GEMINI PROJECT
EA Application: Information Request

PREPARED FOR
MAGNETIC SOUTH PTY LTD

DECEMBER 2020

GEMINI PROJECT
EA APPLICATION
INFORMATION REQUEST

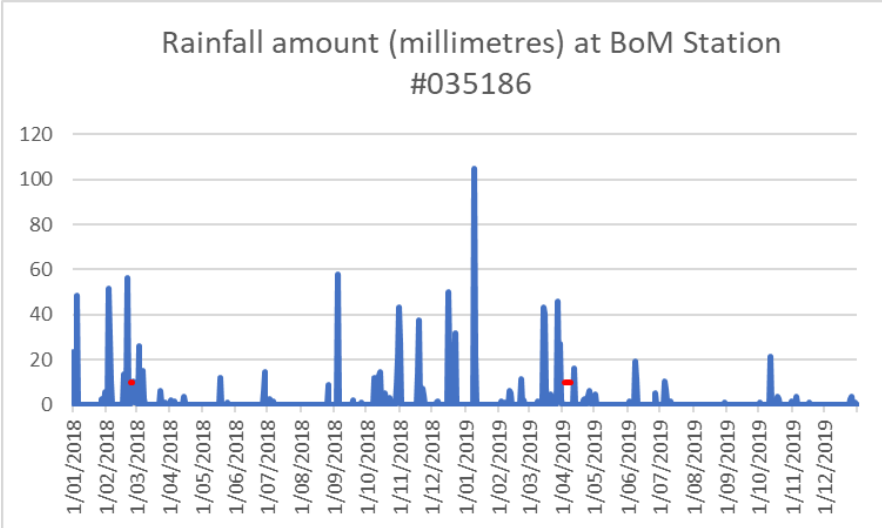
53	Appendix G Section 4.5.4 Fauna Survey Effort - Table 9	An inconsistent method of trapping/monitoring/recording has been utilised for the different seasons. For mammal trapping, 4 sites in Autumn, 6 sites in spring and 5 sites in Autumn have been selected. Why was a survey not completed in Spring 2018? The results that have been formulated do not identify animal correlation between seasons and species in the MLA as they cannot be appropriately comparable.	Justification on the amount of surveying conducted in the two different seasons over the course of the surveying period.	<p>Sections 1.1 and 4.5.4 of Appendix J to the <i>EA Application: Revised Supporting Information</i> document has been updated to provide clarification on the survey effort undertaken during the Flora and Fauna surveys. Section 1.1 of the Appendix J identifies the scope of the flora and fauna field surveys was 'to develop an inventory of terrestrial flora and fauna species inhabiting the study area, particularly species of conservation significance'. As such, field surveys were designed using the stratified sampling methods as detailed within the <i>Terrestrial Vertebrate Fauna Survey Guidelines of Queensland</i> (Eyre et al 2018) and <i>Queensland Herbarium Methodology for Survey and Mapping of Regional Ecosystems and Vegetation Communities in Queensland Version 4.0</i> (Neldner et al 2017).</p> <p>It is considered that the fauna survey effort comprehensively the addresses the objective of the field surveys described in Section 1.1 of Appendix J. This objective is to identify terrestrial fauna inhabiting the study area, particularly species of conservation significance.</p> <p>The fauna survey was planned according to the <i>Terrestrial Vertebrate Fauna Survey Guidelines for Queensland V2.0</i> (Eyre et al 2014), the current version at the time of all surveys. These guidelines state that trapping should target each habitat unit identified within the study area at least three times across the identified survey seasons. The Project is located within the Brigalow Belt bioregion, which the fauna survey guideline recommends surveying during Spring and Autumn (Eyre et al 2014). Due to access restrictions, the fauna trapping and recording took place in Autumn 2017, Spring 2017 and Autumn 2018. The <i>Terrestrial Vertebrate Fauna Survey Guidelines for Queensland V2.0</i> (Eyre et al 2014) states that '<i>...at least two surveys undertake in different seasons will be a minimum requirement...</i>'. As such, it is understood that the fauna survey guidelines requirements have been met with the three surveys, and no further survey effort was considered necessary in Spring 2018.</p>

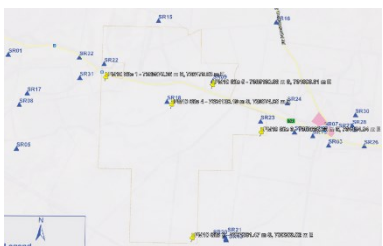
96	Appendix I Section 3.5 Air quality impact assessment	<p>Section 3.5 discussed the results produced from the air quality modelling.</p> <p>Each of the subsections within Section 3.5 stated that “using standard, and when necessary, additional mitigation</p>	<p>Update the air quality model, and results, to reflect the NPI manual.</p> <p>Describe in detail the mitigation measures to be</p>	<p>Refer to issue number 95 regarding the emission reduction factor used and the feasibility of the proposed mitigation measures.</p> <p>Similarly, refer to Appendix B (Surface Water Assessment) of the <i>EA Application: Revised Supporting Information</i> document that demonstrates adequate amounts of water will be available to meet the water demand for the proposed dust suppression.</p>

Issue No.	EA Application Chapter /Section	Regulator Comment	Information Requirement	Magnetic South Response
		<p>measures predicted 24-hour average and annual average concentrations of PM₁₀ comply with relevant air quality objectives at all sensitive receptors. Additional mitigation measures may include restricting overburden and ROM haul to between 7am and 6pm on days when 24-hour averaged maximum PM₁₀ is predicted to exceed 50 µg/m³."</p> <p>Table 5, Section 3.4.2, stated that an 85% reduction factor for hauling of ROM coal and hauling of overburden has been applied. The National Pollutant Inventory Emission Estimation Technique Manual for Mining (NPI manual) only allows 50% for level 1 watering (2 litres/m²/hr) and 75% for level 2 watering (>2 litres/m²/hr). As such, the department considers that the modelled results are significantly underestimated.</p> <p>No further information has been provided in relation to which mitigation measures were applied in the model or in which instances that these mitigations are likely to be applied.</p>	<p>applied to mitigate impacts to air quality resultant from the Gemini Coal Project, including an assessment of the feasibility of the mitigation measures in application.</p> <p>Provide information to confirm that adequate amounts of water will be available to meet the water demand for the higher rate of watering required for the Level 2 rate of greater than 2 litres/m²/hr.</p>
